Subject: VIRGIL C. SUMMER NUCLEAR STATION  
DOCKET NO. 50/395  
OPERATING LICENSE NO. NPF-12  
TRANSMITTAL OF RADIATION EMERGENCY PLAN REVISION 50

DOCUMENT EP-100 REVISION 50 CHANGE N/A DATE 4/20/05

TITLE: Radiation Emergency Plan

**Figure 9-1  
RECOVERY ORGANIZATION**

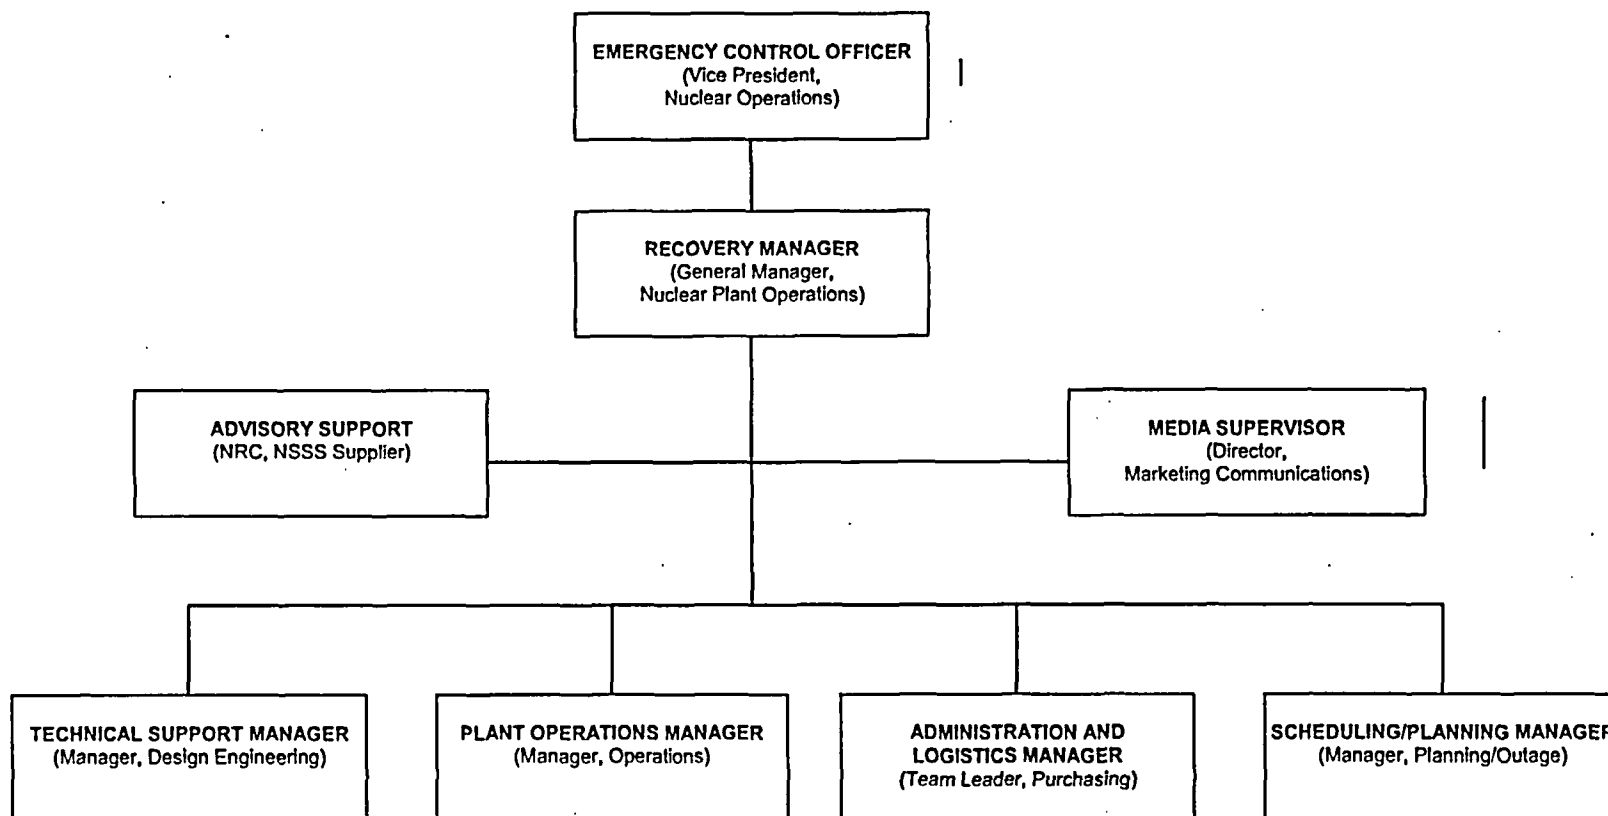
**Description:** Figure 9-1 – changed the titles of two positions to make them current.

**Reason for Change:** Organizational title changes.

Figure 9-1 – changed the titles of two positions to make them current.
